Novi Crescent SP 12-24

Consideration of the request of Novi Crescent LLC for Preliminary Site Plan and Stormwater Management Plan approval. The subject property is located in Section 15, north of Crescent Boulevard and west of Novi Road, in the TC, Town Center District. The subject property is approximately 1.29 acres and the applicant is proposing to demolish the existing Big Boy restaurant and construct a 10,000 sq. ft. building consisting of restaurant and retail space.

PLAN REVIEW CENTER REPORT

SP #12-24

CONCEPTUAL SITE PLAN
 Scale: 1/8" = 1'-0"

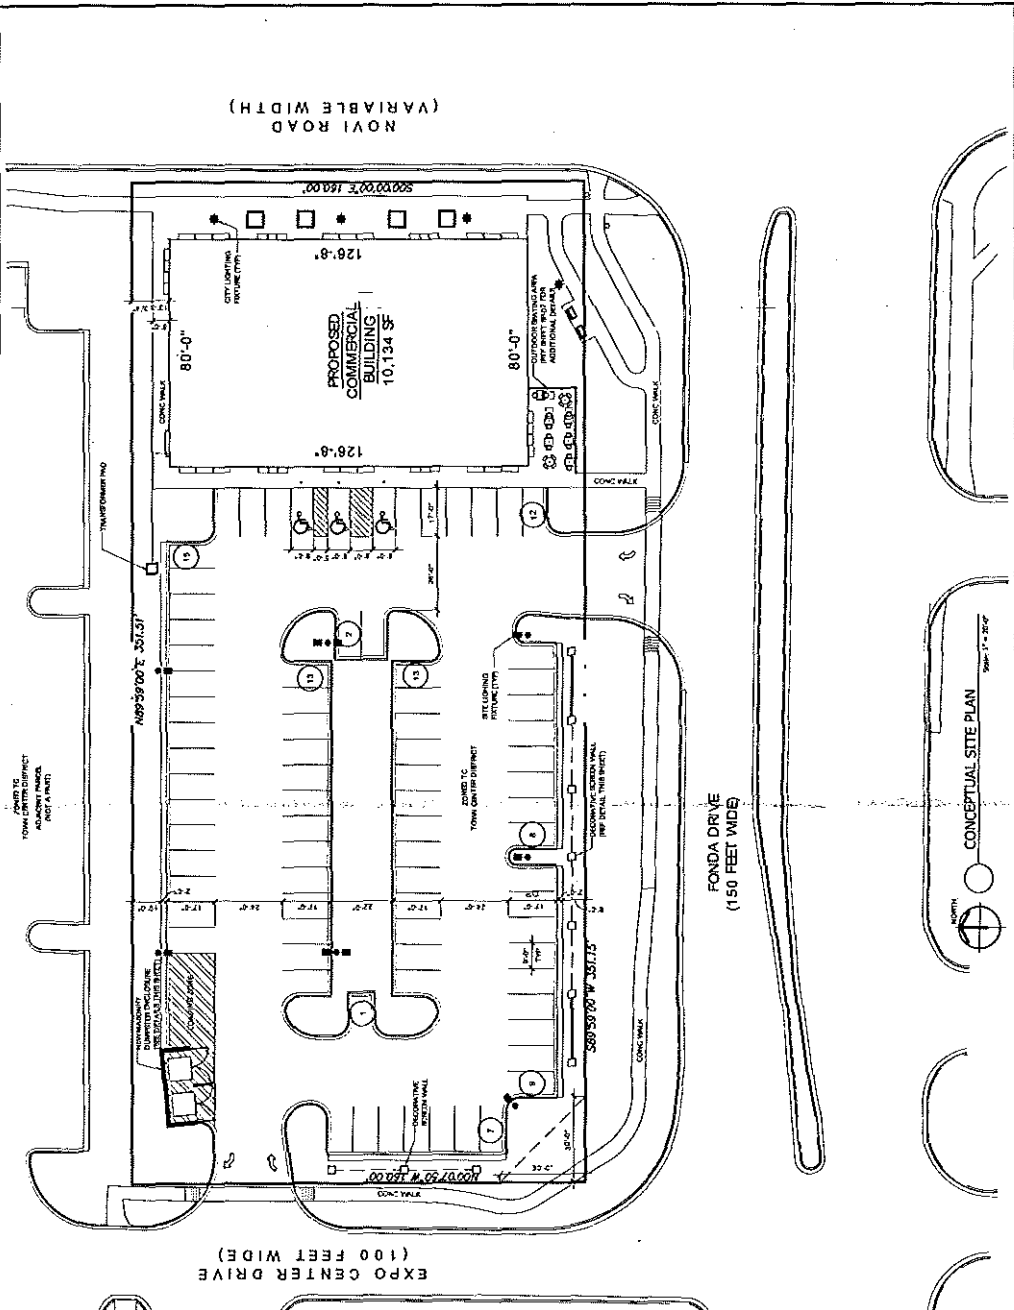
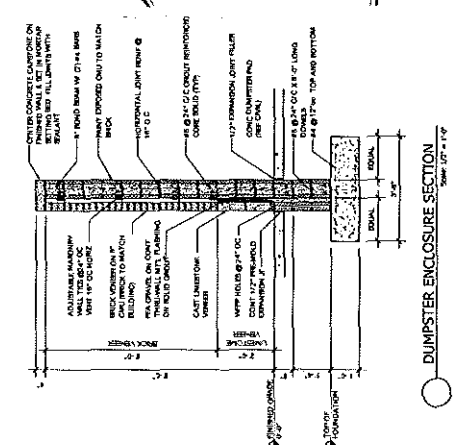
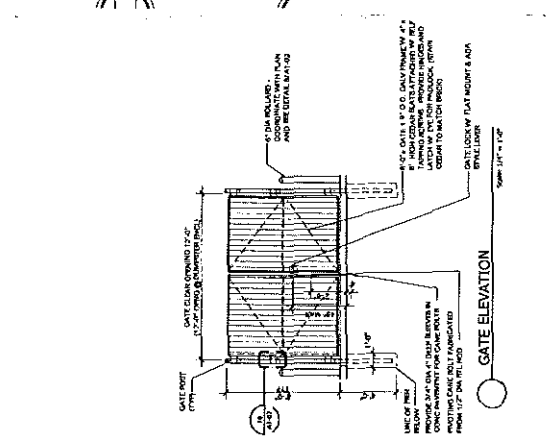
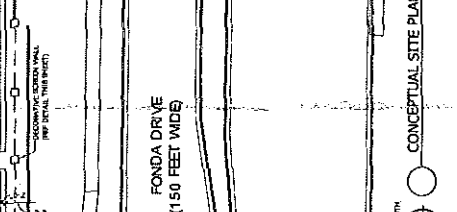
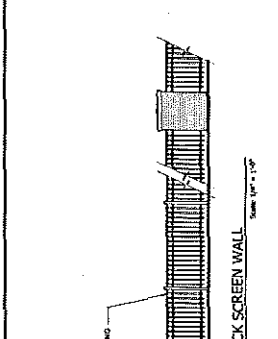
2. Building Setbacks: The proposed building should be setback fifty feet from all property lines. The building setback on the northern side of the property is approximately 14 feet. The building setback on the eastern side of the property is approximately 20 feet. The building setback on the southern side of the property is approximately 20 feet. **The applicant should revise the site to meet the building setback requirements or seek a reduction in the setbacks from the Planning Commission.** Refer to the planning review chart for additional information on items the Planning Commission will consider when determining whether or not to grant a reduction in the required building setbacks.

3. Parking Setbacks: The proposed parking should be setback 20 feet from all front and exterior side yard property lines. The parking in the southern and western yards is setback 10 feet. **The applicant should consider reducing the size of the building in order to meet the parking setback requirements. Alternately, the applicant could seek variances from the Zoning Board of Appeals.**

5. Parking Requirements: A combined 4,600 sq. ft. of restaurant space and 5,534 sq. ft. of retail space requires a total of 94 parking spaces. A total of 80/81 parking spaces have been provided. **The applicant should consider reducing the size of the building in order to meet the parking requirements. Alternately, the applicant could seek a variance from the Zoning Board of Appeals.**

6. Maneuvering Lanes: Maneuvering lanes adjacent to parking spaces must be 24 ft. wide. The striping and paving plan shows the south and west maneuvering lanes as slightly less than 24 ft. wide. The applicant should adjust the plan to allow for the required 24 ft. maneuvering lanes in the south and west portions of the site.

7. Loading Zone: Loading zones in the TC District must be located in the rear yard. The proposed loading zone is located in the exterior side yard. **The applicant should seek a variance from the Zoning Board of Appeals for the loading zone location.** The Zoning Ordinance requires 10 sq. ft. of loading space for each front foot of building in the TC District meaning 800 sq. ft. feet of loading space is required for the subject property. Approximately 650 sq. ft. has been provided. **The applicant should provide an additional 150 sq. ft. of loading space or seek a variance from the Zoning Board of Appeals.** See the landscape review letter for additional information on screening the loading zone. Additional information on the delivery schedule should be provided.

9. Dumpster Location: Dumpsters must be located in the rear yard. The proposed dumpsters are located in the exterior side yard. **The applicant should seek a variance from the Zoning Board of Appeals for the dumpster locations.**

Applicant: We intend to proceed with the site as it is currently configured and seek a reduction in the required setbacks. The 50' Front setback for buildings would adversely affect this site as it is required to provide this setback on three sides, Novi Road, Crescent Blvd., and Expo Center Drive, reducing the developable envelope substantially. The Planning Commission is permitted to grant this reduction according to the Zoning Ordinance 1602.4 (a).

Applicant: We will revise the maneuvering lanes to 24' with the stamping set is submittal.

Applicant: We will be seeking a Variance for the location of the Loading Zone, because this site has frontages on three streets the location of the Loading zone falls in a Front yard setback (Expo Center Drive). The building that we are proposing is consistent with others in the Town Center district in that they are pushed forward toward the ROW and accessed from the rear to create a downtown feel. This makes locating the loading zone next to the building in a rear yard virtually impossible. With regard to the size of the loading zone, we will revise the layout to increase the loading space by 150 Sf.
